AGENDA
Historic Yorktown Design Committee

SUBJECT: Application No. HYDC-278-25, Jeffrey Vance, 114 Ballard Street: Request for review of new front yard fence

SUBJECT: Application No. HYDC-280-25, County of York, replace existing tent behind the Freight Shed with permanent pavilion, 331 Water Street

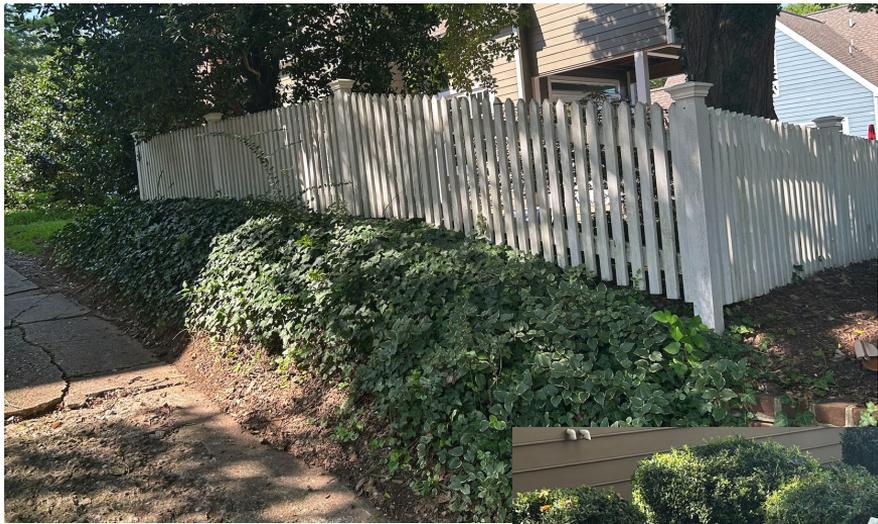
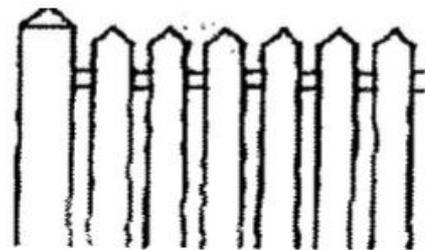
This application, submitted by Jeffrey Vance, seeks approval to install a new front yard white picket fence at his home at 114 Ballard Street. The applicant proposes to install the fence just above the retaining wall that runs along the front of his property. It would have a pedestrian gate over the existing stairs in the retaining wall and would run behind the Nicolas Martiau monument on the applicant's property, to preserve public access to it.

The fence would end at the southwestern property line that abuts 120 Ballard Street. On the northeastern end of the property, the fence would turn ninety degrees (90°) and run partially up the driveway.

The fence is proposed to have a picket style, be made of wood, and painted white. The pickets would be three and one-half inches (3.5”) in width and forty inches (40”) or three feet and four inches (3’ 4”) in height. The pickets would have a “slight pyramid point” and would be spaced two and one-half inches (2.5”) from each other. The post caps would be a flat pyramidal style that matches those on the fence located in the backyard of the subject property.

The pickets on the pedestrian gate would have a concave design across the top, while the pickets on the fence would be of equal height.

1. Except as set forth herein, the fence shall be constructed in accordance with the sketch plan and narrative description provided by the applicant and received by the York County Planning Division on August 25, 2025, copies of which shall remain on file in the office of the Planning Division.
2. The fence shall be painted white on or before August 25, 2026.

Michael Lulofs – 210 Smith Street

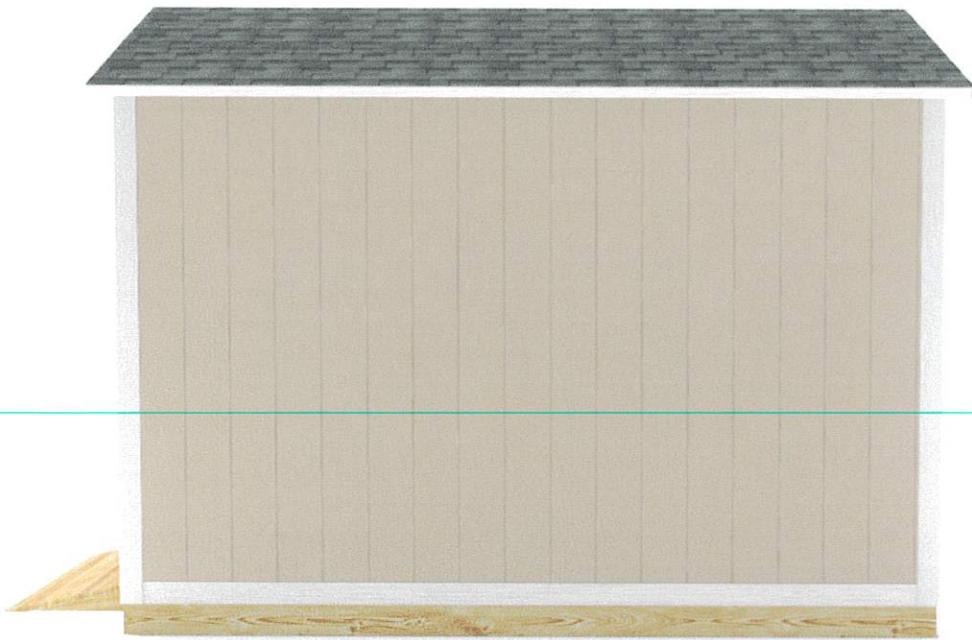
The shed will sit on a foundation constructed of four-by-four-inch (4' x 4') wooden slats placed on the ground. Finally, it's proposed to have double doors that would measure six feet wide by six feet and eight inches tall (6' x 6'8"). The doors would be constructed of the same material and painted the same color as the walls of the shed. An application, narrative description, elevations, and a sketch plan provided by the applicant are attached.

<p>b. Size and Scale</p> <p>New additions and outbuildings should not equal or exceed the ground floor footprint of the principal building on the lot.</p>	<p>The shed would be 96 sq. ft. in size, while the one-story principal building is 1,381 sq. ft. The proposed outbuilding would not exceed the ground floor footprint of the building.</p>
<p>E. New Construction</p>	
<p>1. Residential Construction</p>	
<p>b. Planning for New Construction</p> <p>(3) Size and Scale</p> <p>(d) The footprint of dependencies should not exceed 25% of the footprint of the principal block of the primary structure on the lot.</p> <p>(e) Dependencies should not exceed the height of the primary structure or one and one-half stories, whichever is less.</p> <p>(4) Form and Massing</p> <p>(a) Building designs should be a single rectangular box-like form or a similar principal form with subordinate rectangular wings.</p> <p>(b) The need for increased</p>	<p>The footprint of the principal block of the primary structure is 1,381 sq. ft. Twenty-five percent of 1,381 is 345.25 sq. ft. The proposed shed would be 96 sq. ft. The footprint of the shed would not exceed 25% of the footprint of the principal block of the primary structure on the lot.</p> <p>The height of the home (the primary structure) is twenty-five feet (25'), while the shed (a dependency) is proposed to be ten feet (10') tall. A residential story is generally eleven feet and seven inches (11'7") tall, not accounting for the crawl space, attic, or varying floor thicknesses. One and one-half stories could be about seventeen feet and four and a half inches tall (17'4.5") with wide variation. Nevertheless, the height of the proposed dependency would not exceed the height of the primary structure or one and one-half stories.</p> <p>The shed would be a single rectangular box-like form</p> <p>The need for increased square footage is</p>

1. Except as set forth herein, the shed shall be constructed in accordance with the sketch plan and narrative description provided by the applicant and received by the York County Planning Division on August 20, 2025, copies of which shall remain on file in the office of the Planning Division.
2. The pitch of the utility shed's roof shall be in the range of 9:12 to 12:12.
3. The foundation of the utility shed shall be brick-faced.
4. The utility shed's siding shall be clapboard (horizontally oriented). If composite siding is used, it shall have a wood-grain finish.
5. Except for the transom window, double-hung sash windows shall be used. Wood or wood-like composite material windows with vinyl or metal cladding shall be used.

OPTION A

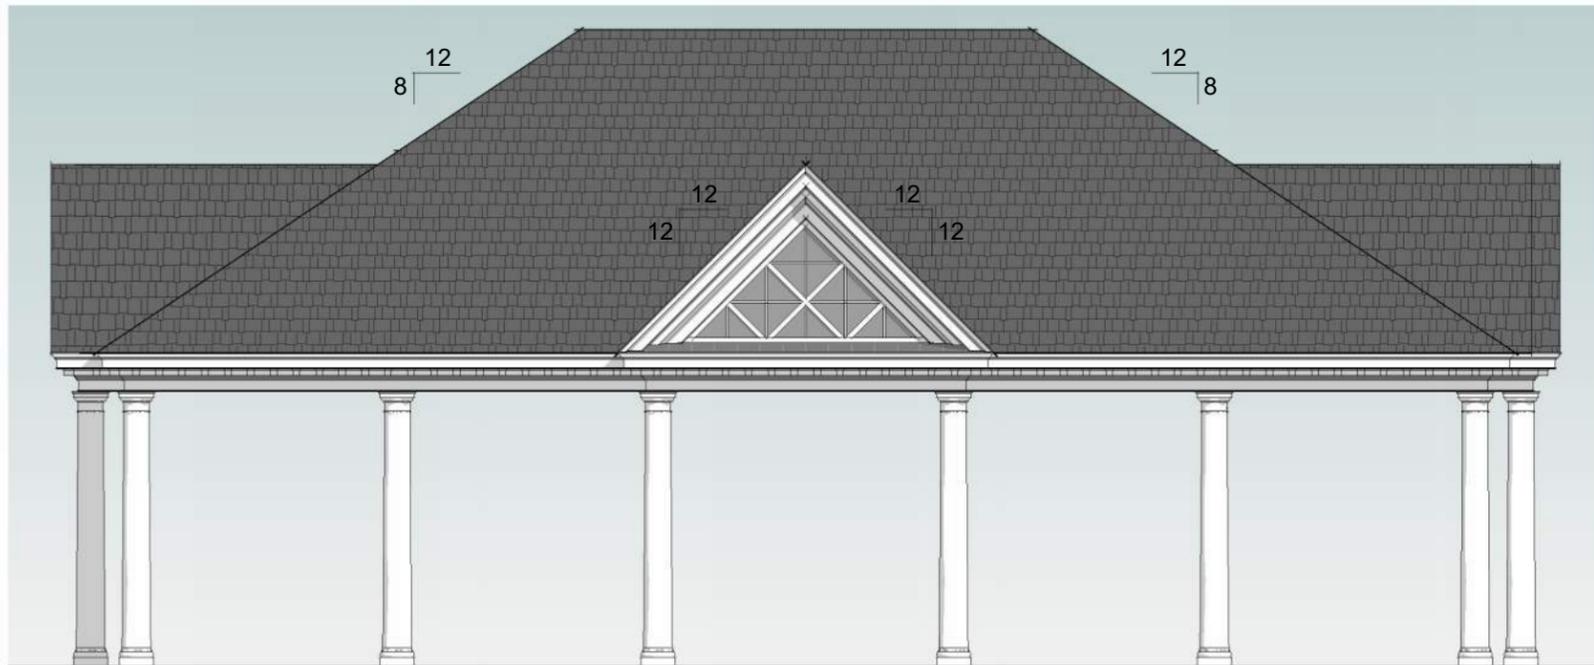
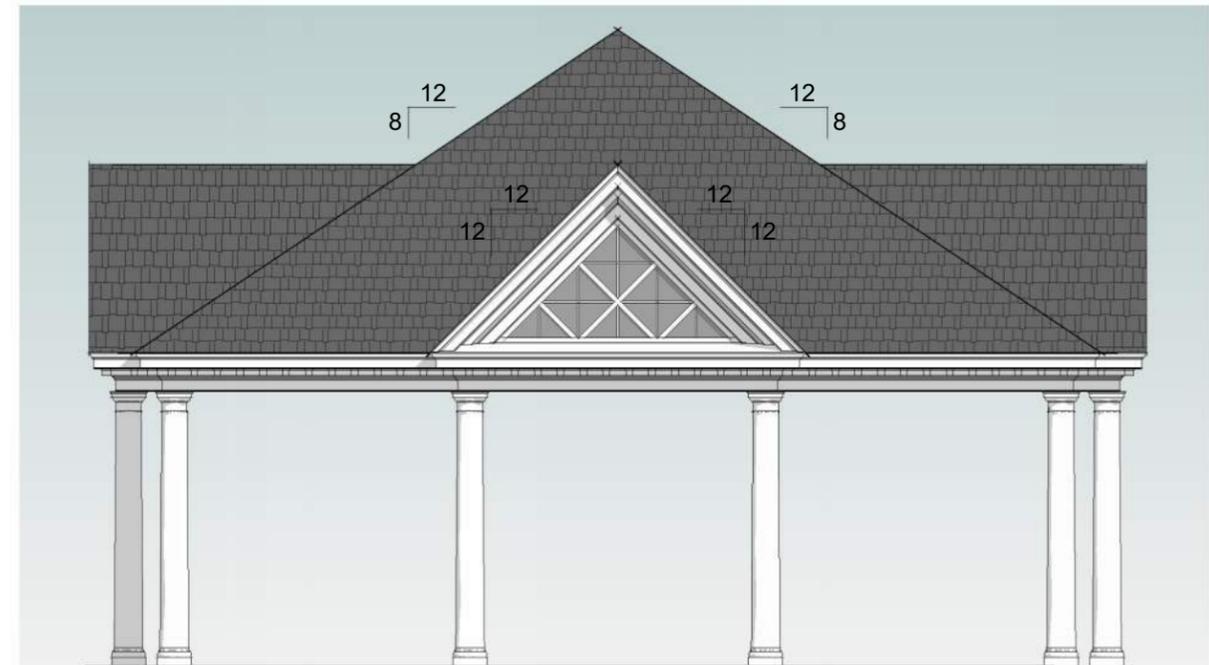
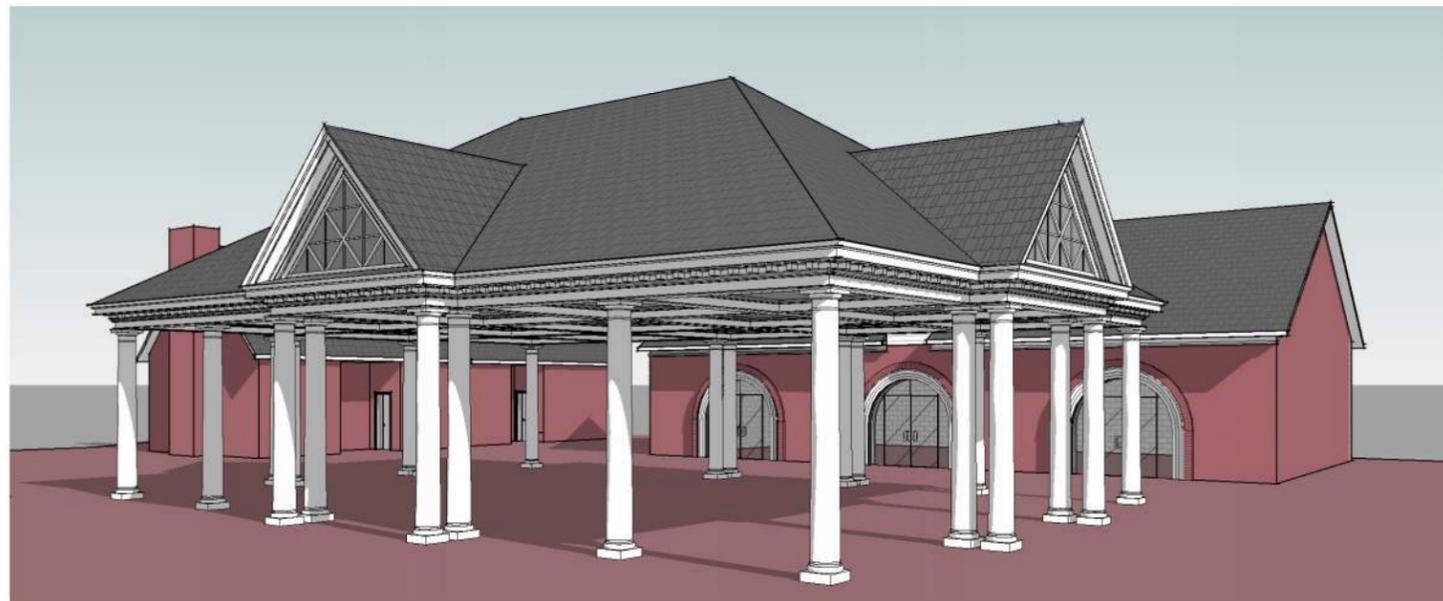
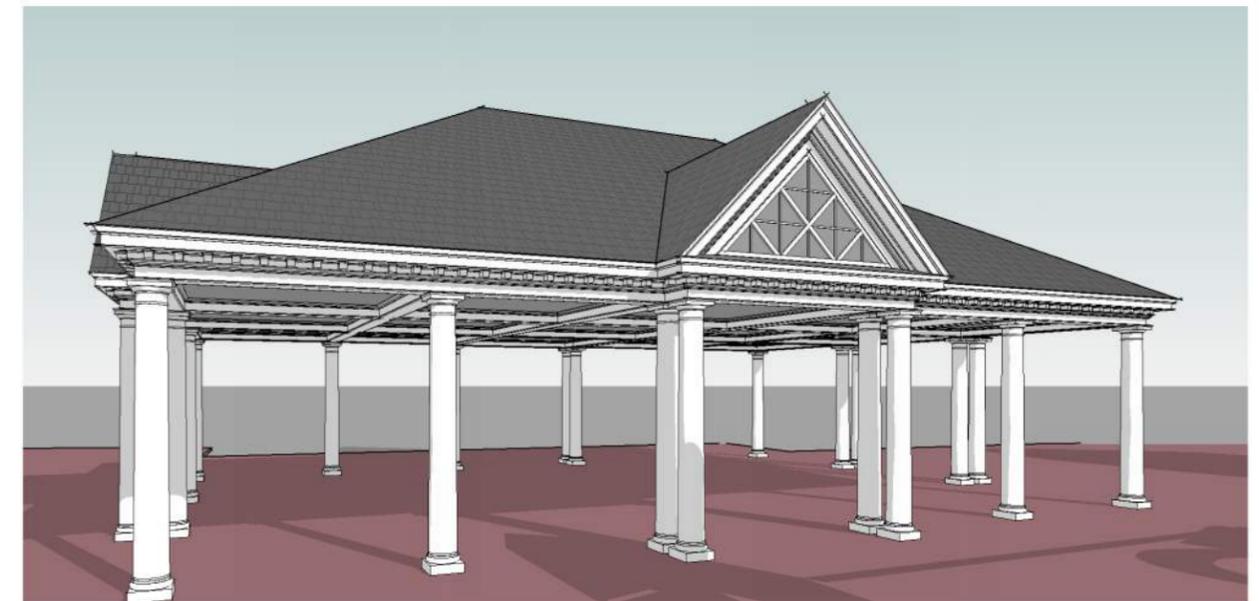
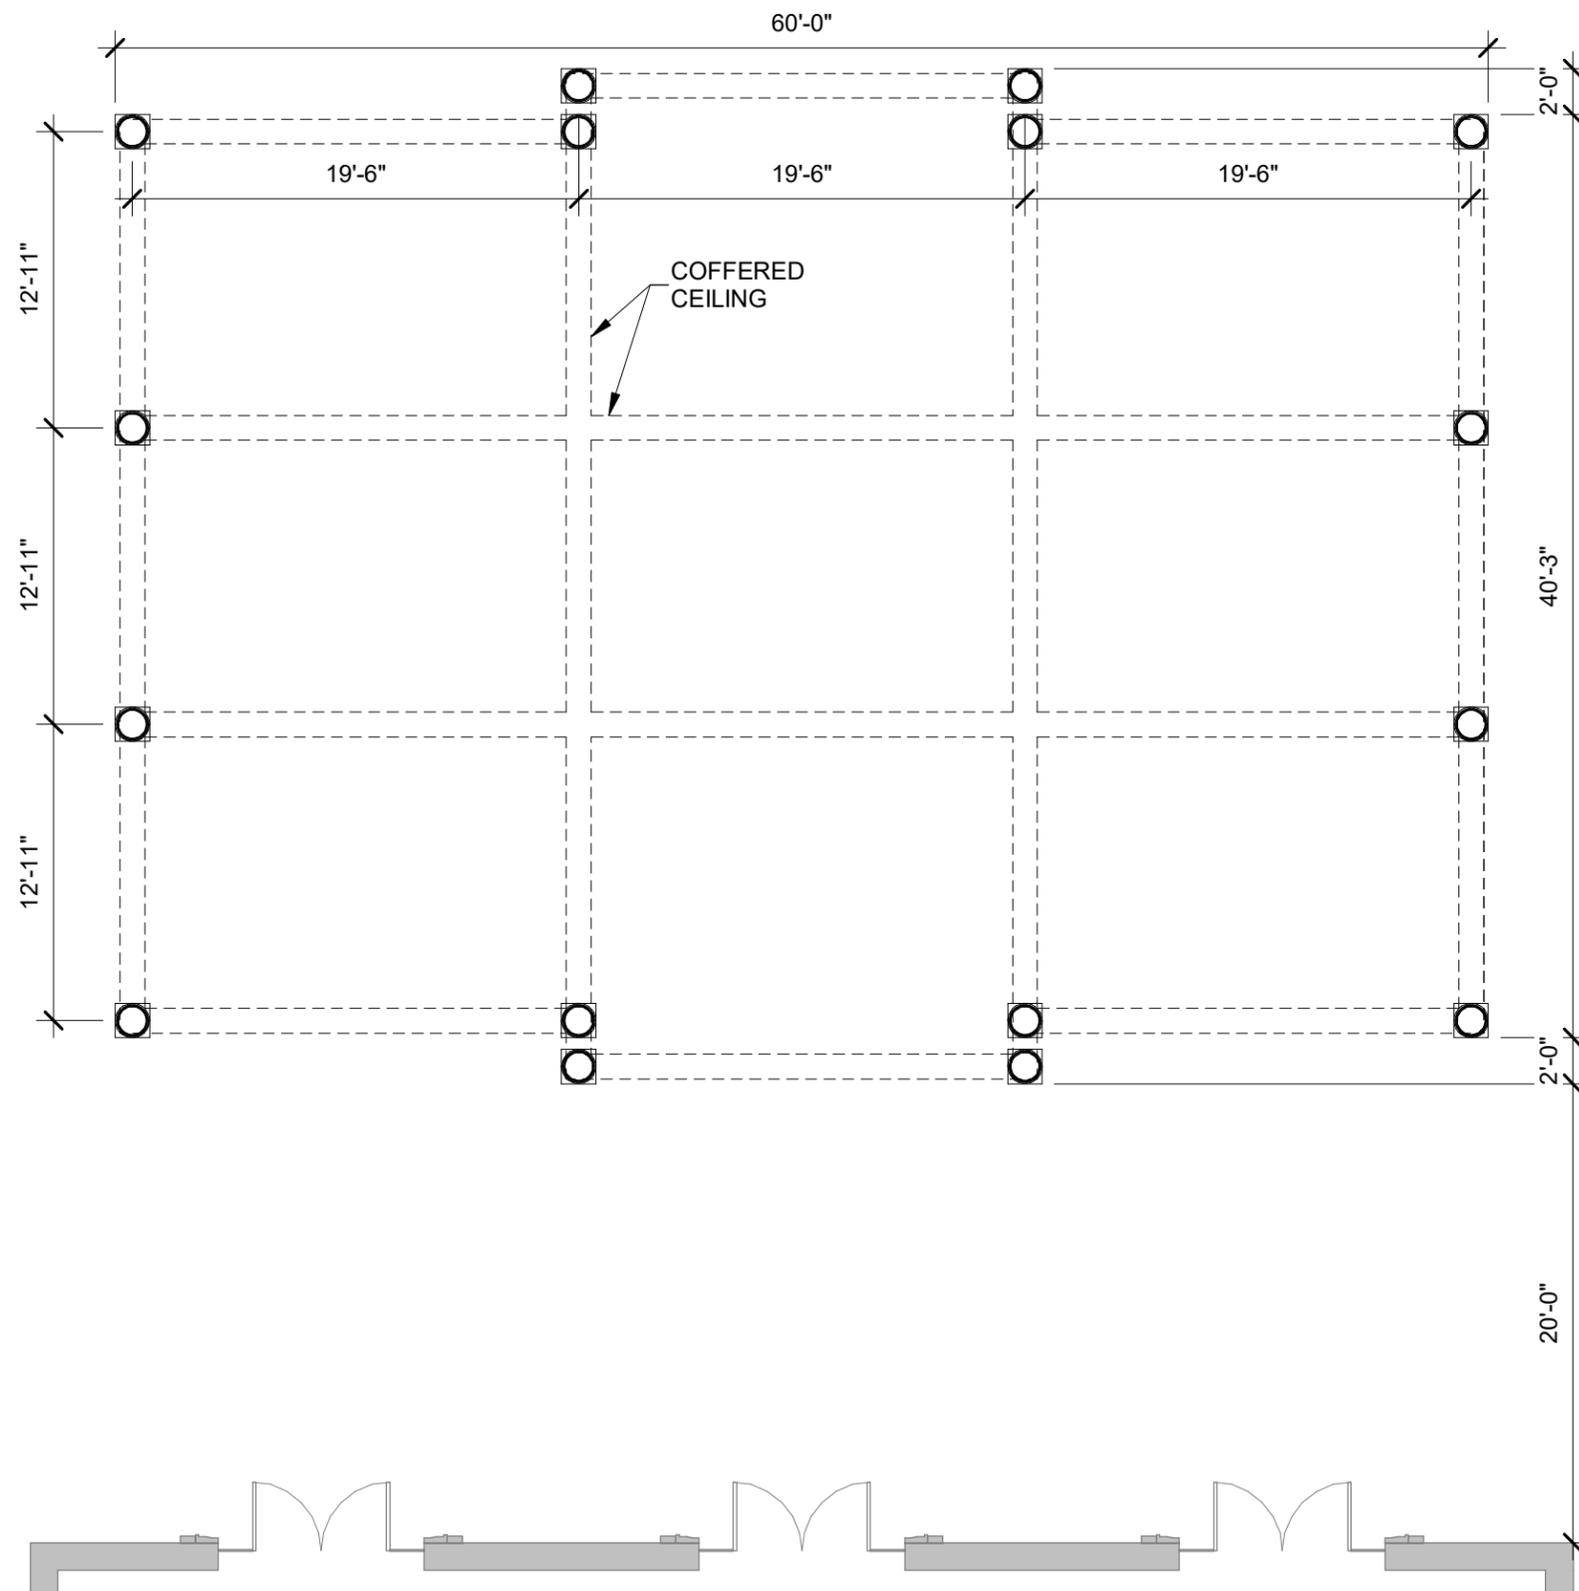
Option A features a hipped roof with small cross gable roofs that project from each of the four (4) sides of the hipped roof. The gable ends of the smaller roofs feature decorative lattice truss detailing in the tympanum (the triangular space within the gable), which is outlined by cornice trim. Behind the lattice truss detailing in the tympanum would be grey Hardieplank. All the trim and lattice work would be white. The main roof would have a slope of 8:12 and the smaller gabled roofs would have a slope of 12:12. The rendering of Option A, provided by the applicant, appears to show twenty-four (24) columns.

3. What materials would be used for the end gables? It looks like siding—is it hardiplank, wood, or something else.
 - a. It would be Hardie planks and trim. Options A and B show a design on each gable end; which would have background of Hardie planks in gray and the trim (to mimic the design) would be in white. For options C & D this siding material would be Hardie planks in white.

- a. PVC trim; trim would be painted to match the Freight Shed white.
7. Will the Hardiplank on the end gables be white?
 - a. For options C & D.
8. The compartments that hold the roll-down screens would be inset into the structure or attached to the exterior. If they're inset, they would be invisible, right? If they're attached to the exterior, they'll be black?

1. Main roof: 8:12
 2. Gables: 8:12
12. What is the slope of the Freight Shed roof?
 - a. We do not have an existing plans for this building so I will not be able to get you this information.

- a. No, it will have neither.
17. What type of edge will the Hardiplank have? How many inches will the Hardiplank have exposed?
 - a. It will be beveled and I am not sure of the exact amount of the Hardie plank that will be exposed. I would assume it would be no more than the 6" mentioned within the guidelines.

1. The pavilion shall be constructed in accordance with the application materials submitted by the applicant and received by the Planning Division on September 19, 2025, copies of which will remain on file with the Planning Division, except as modified herein.
2. Clapboard siding shall have approximately 6 inches of exposure.
3. Trim shall not exceed 2 inches in actual thickness, 6 inches in width at corners and 4 inches around openings.
4. All colors shall be selected from the Yorktown Color Palette.
5. All windows shall be square or vertical in proportion.
6. The primary roof shall be of a symmetrical gable style with no less than a 9:12 slope.

- All decorative trim around the roof line (fascia and soffits) shall be wood, painted white.
